REGULAR PLANNING COMMISSION MEETING

Wednesday, January 15, 2025 @ 7:00pm

Agenda Item: Application for Preliminary Plan Approval Major Subdivision #2400421

RE: Comments on Preliminary Plan dated October 15, 2024 (2nd Submittal)

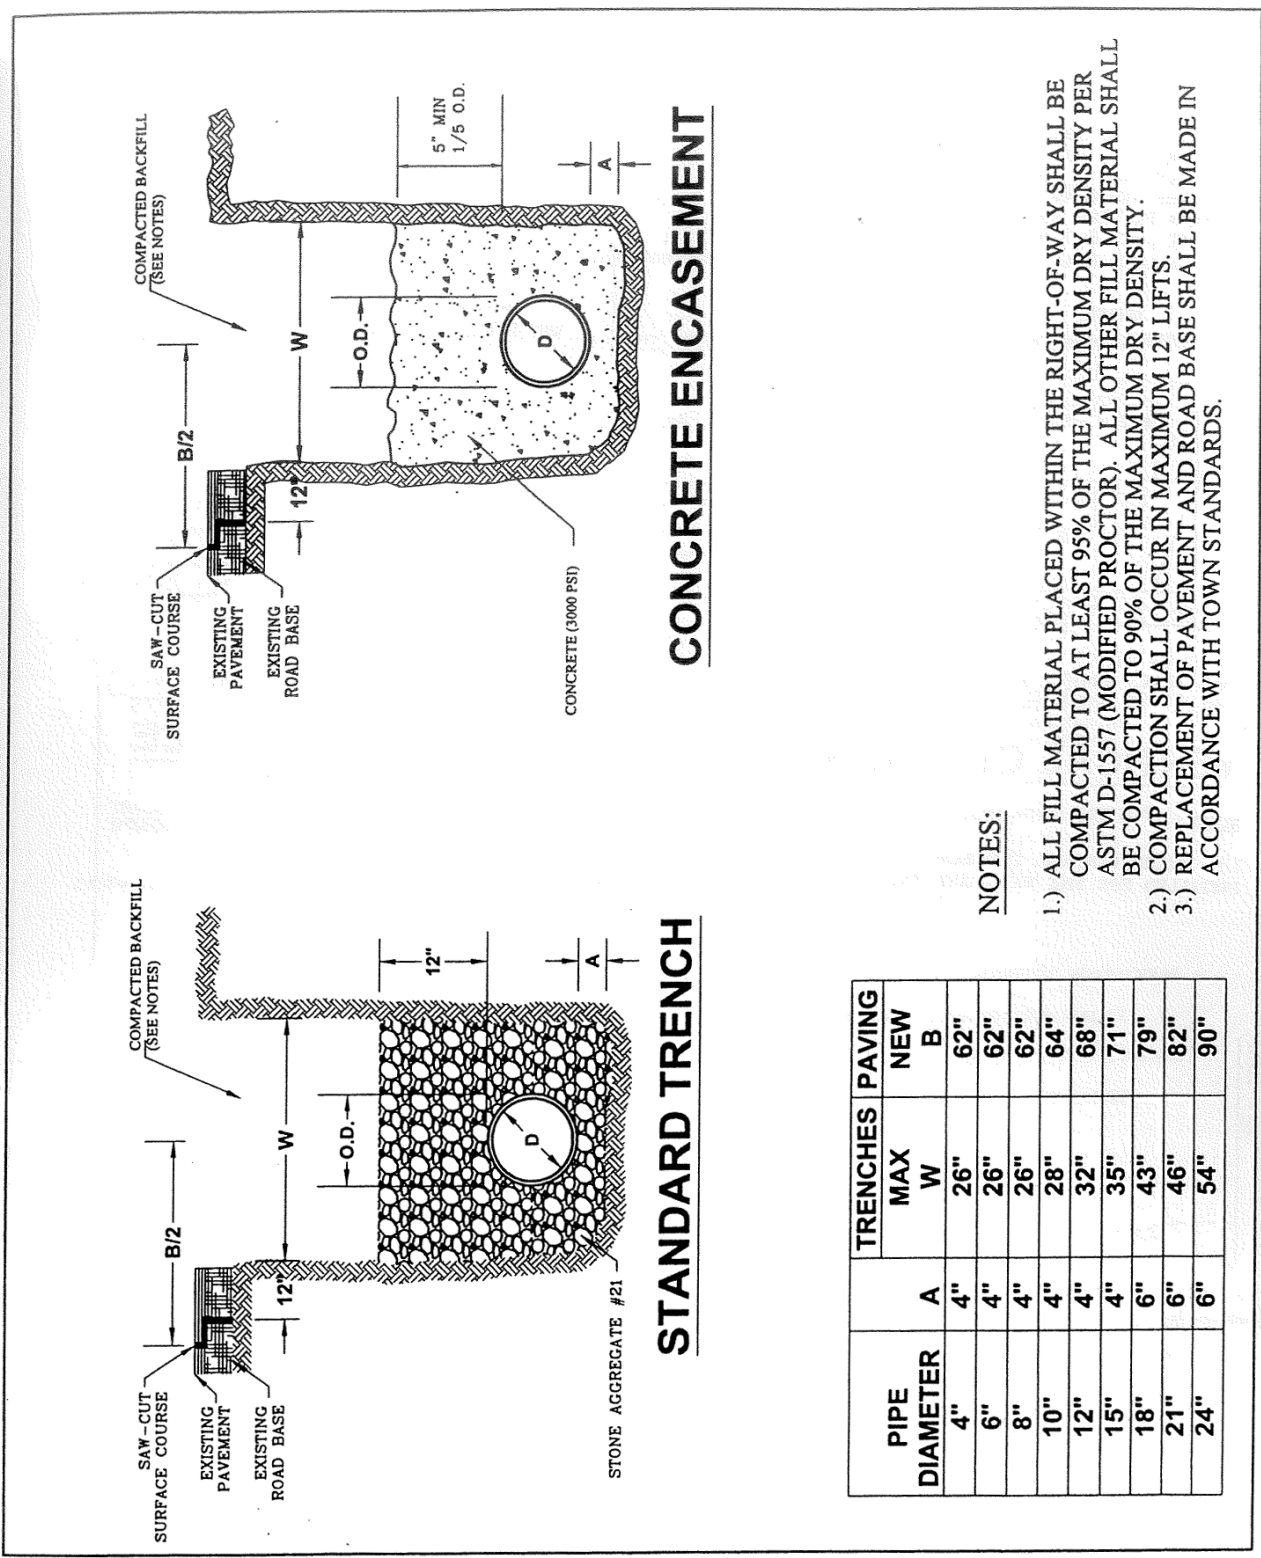
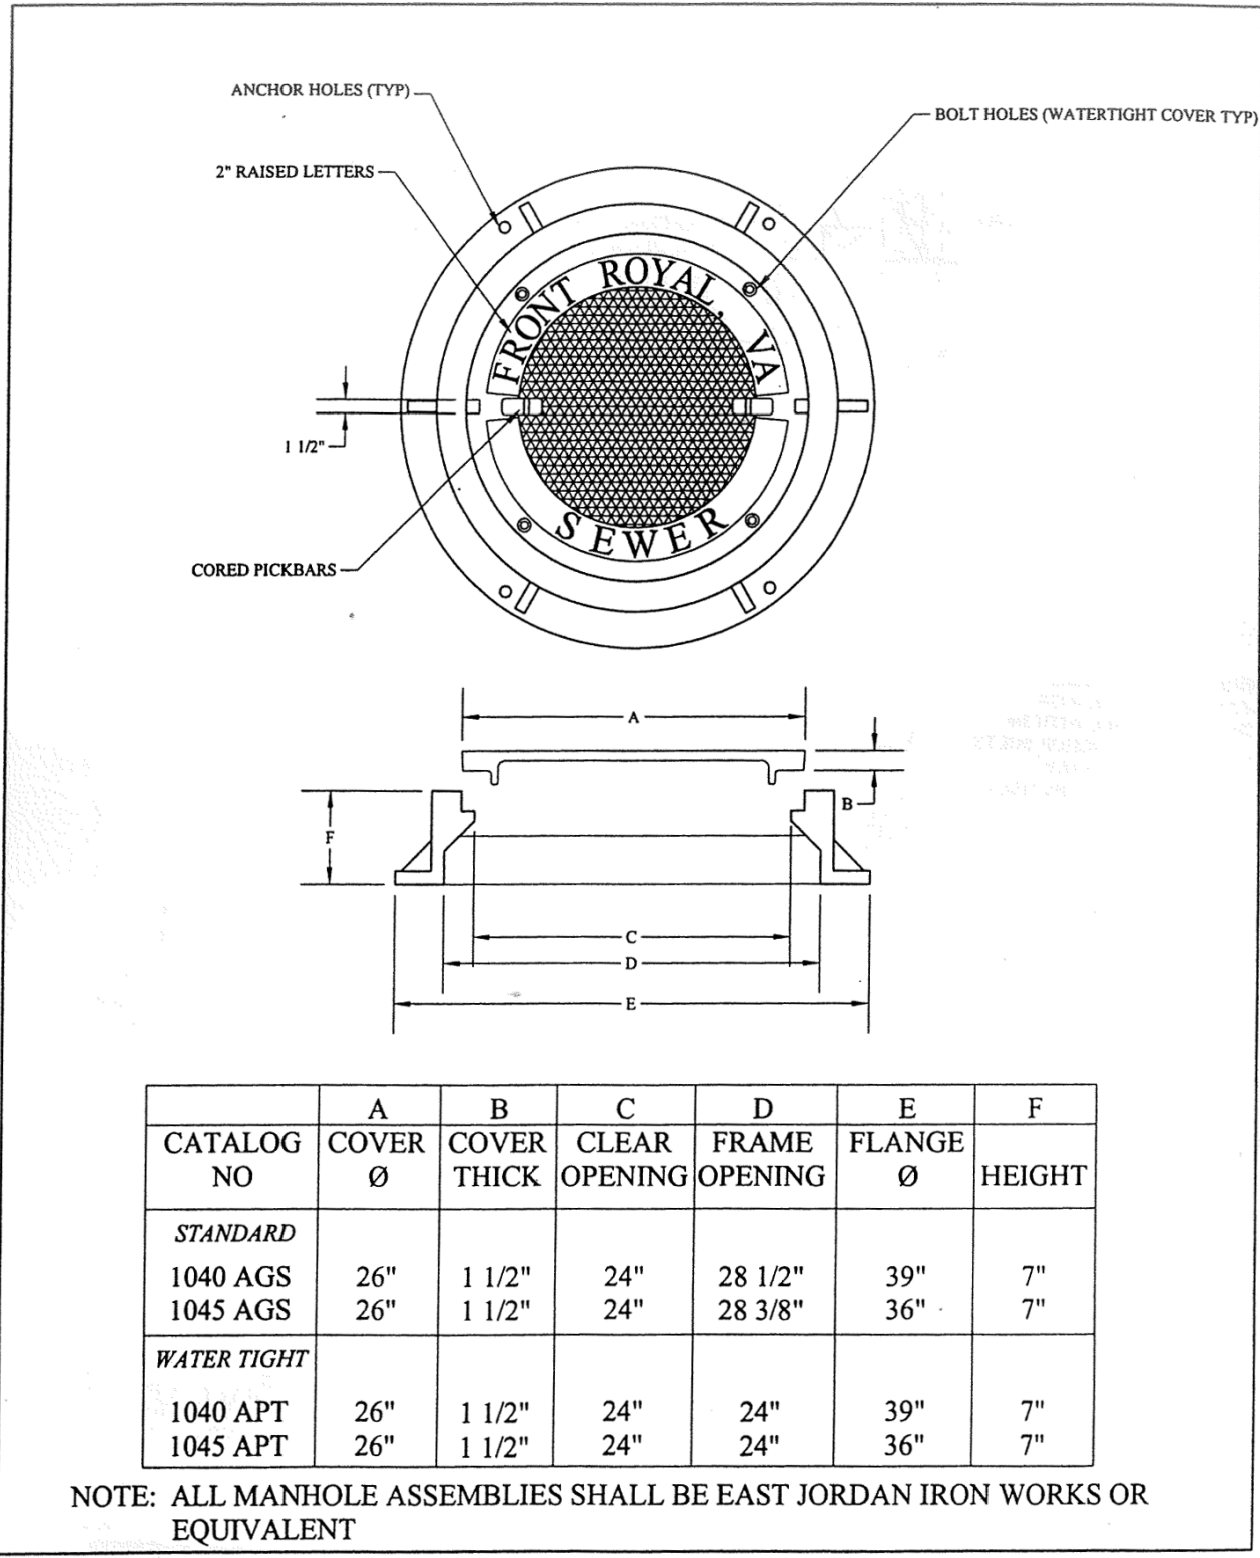
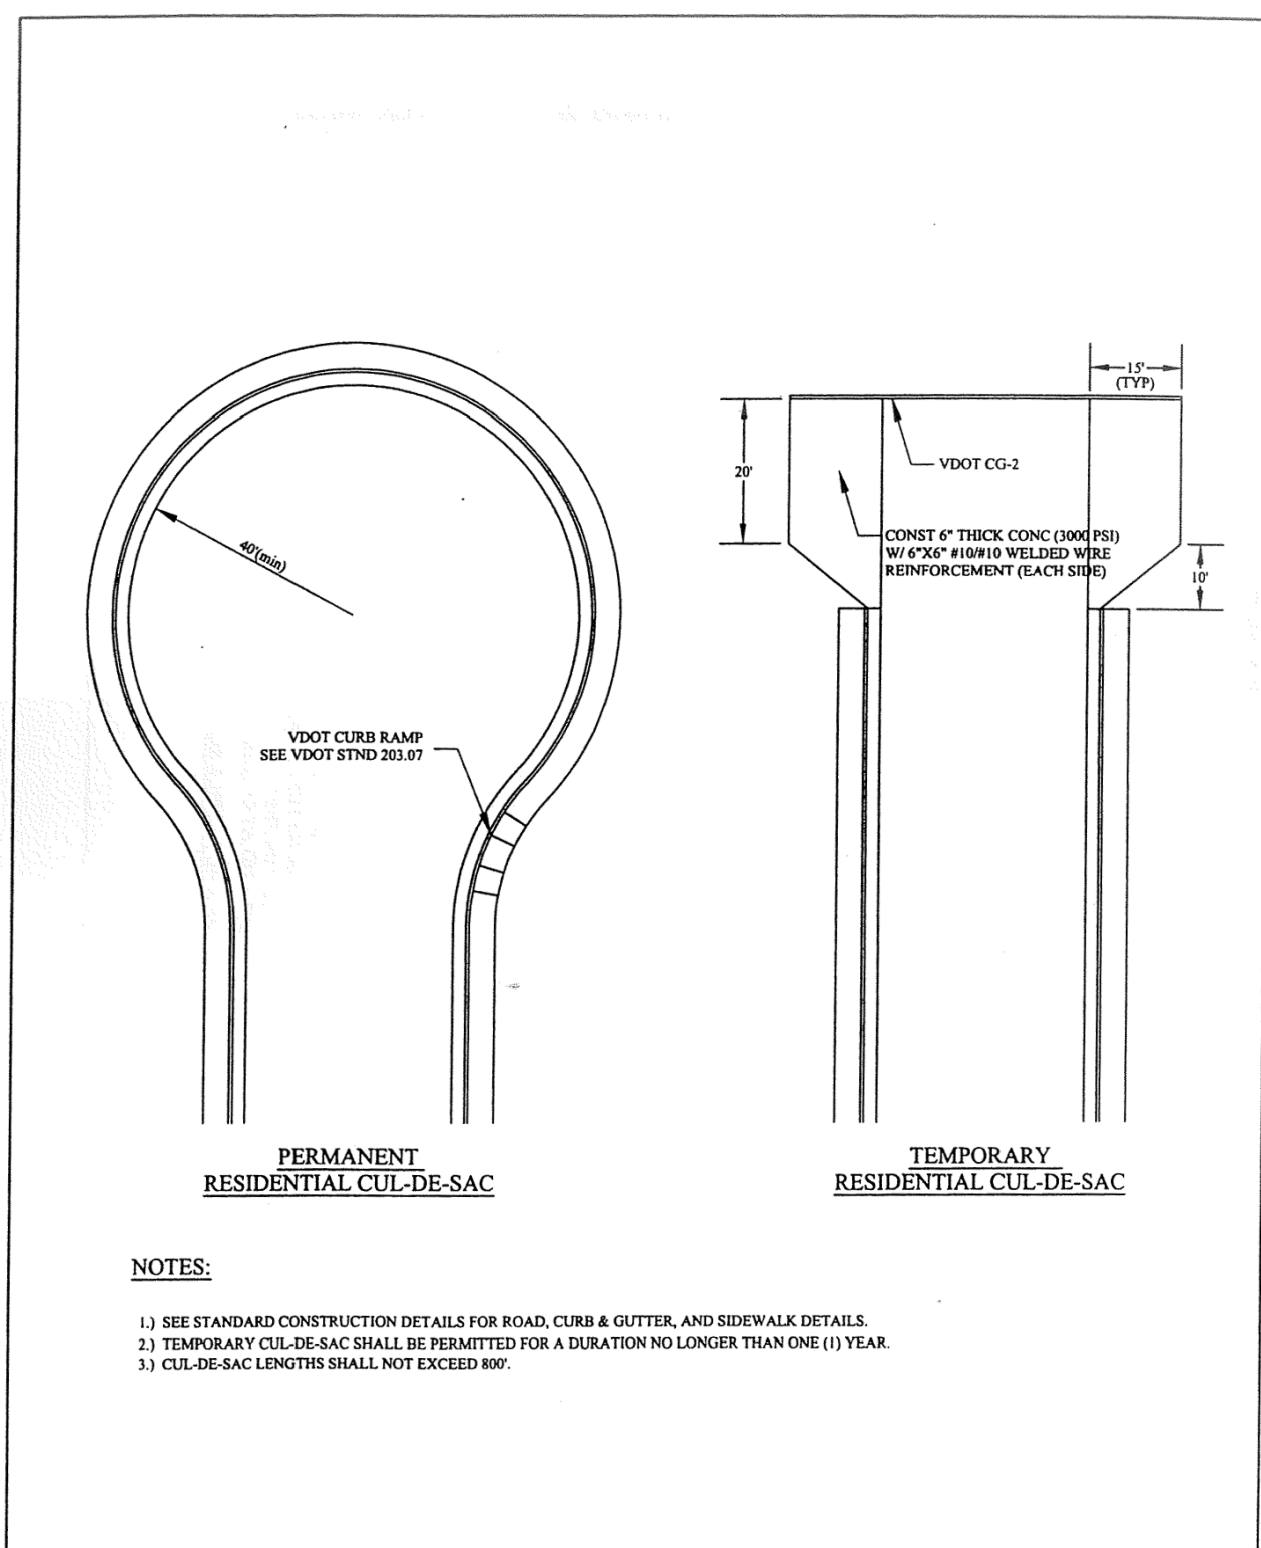
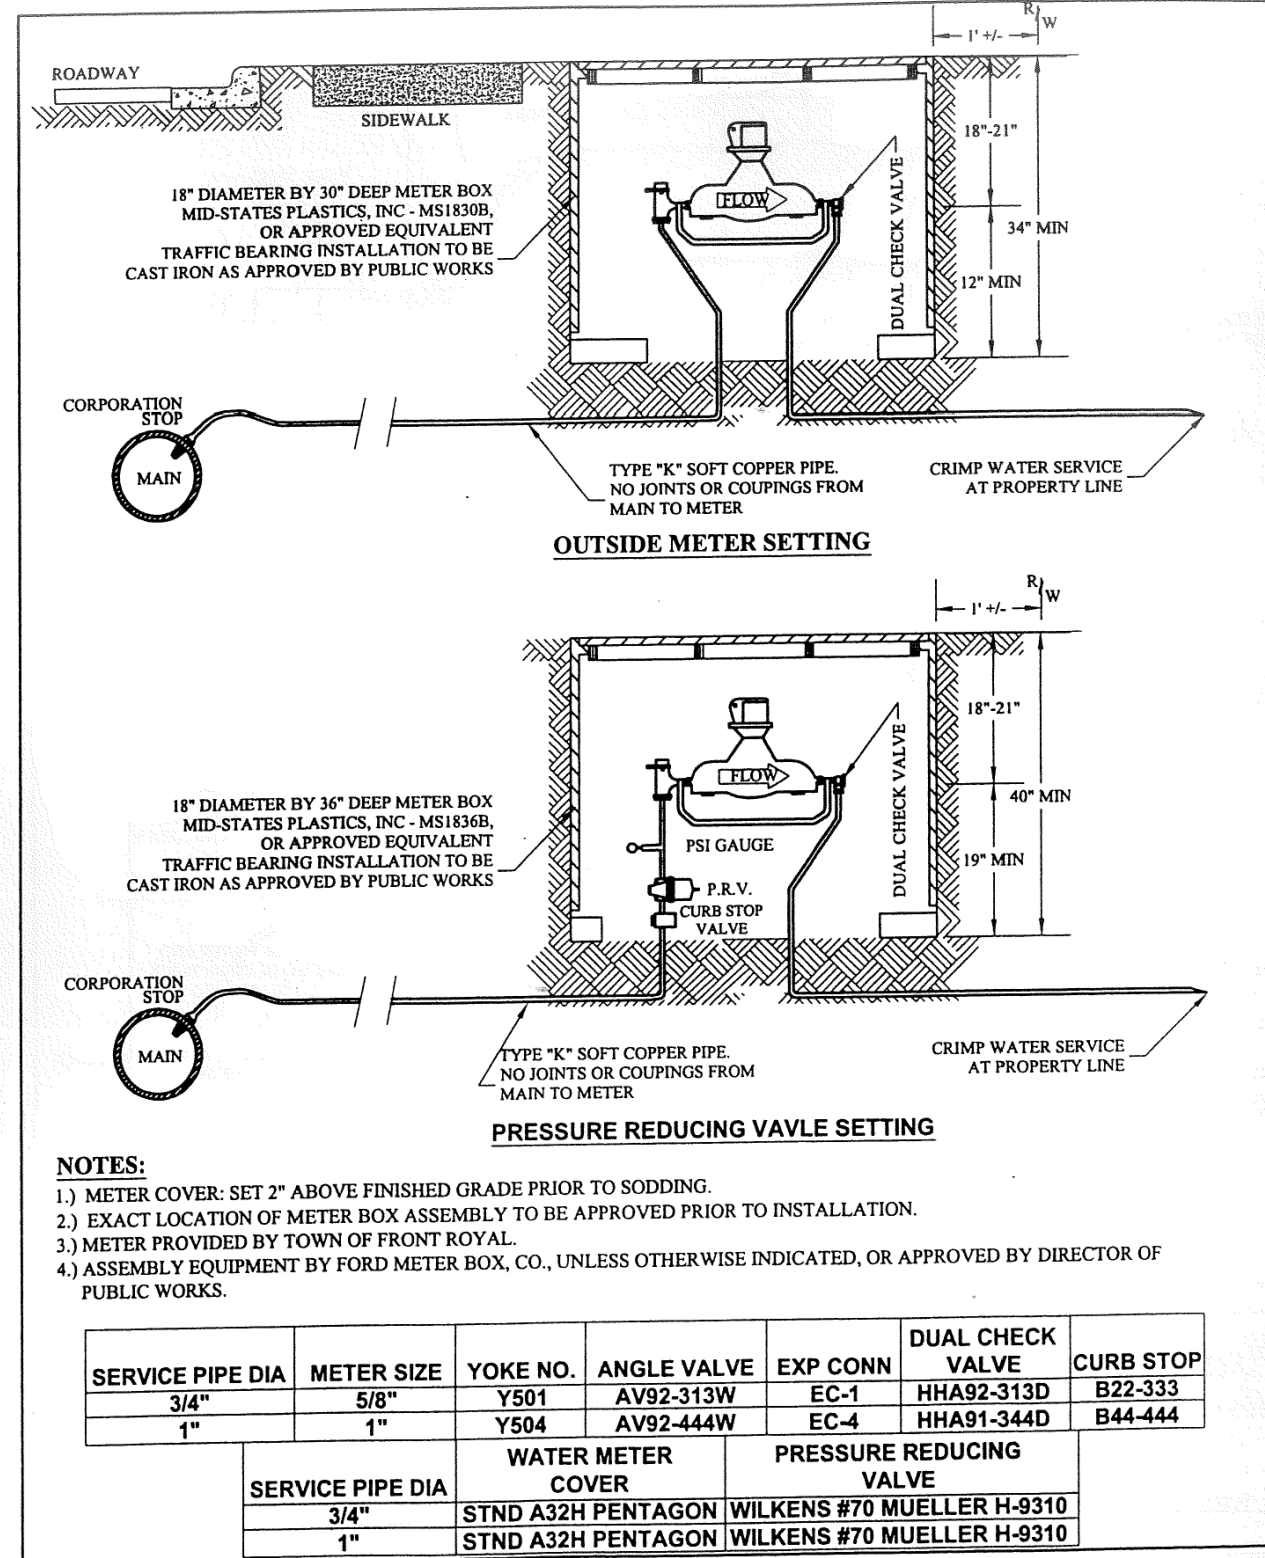
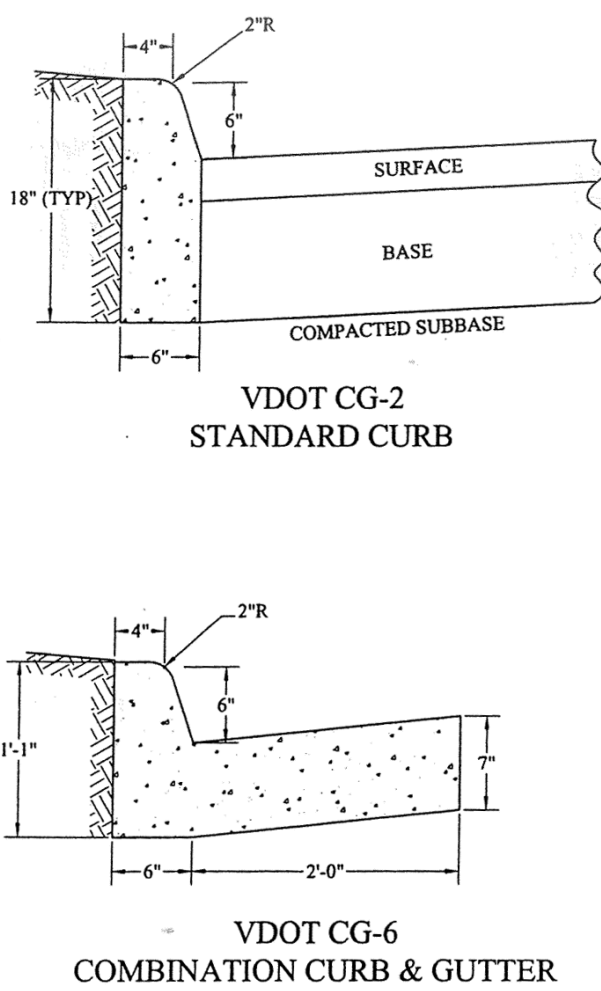
7. Sheet C200 needs to have the CG-6 curb and gutter and CG-9 driveway aprons labeled and shown.
8. Sidewalk still needs to be shown on the plans, there's no approved waiver for the sidewalk at this time.
9. Town standards need to be added to the detail sheet, W-6, S-10, S-1, RC-1, RC-2, RC-4, and RC-5.

Response: Standard details have been added to sheet C503.
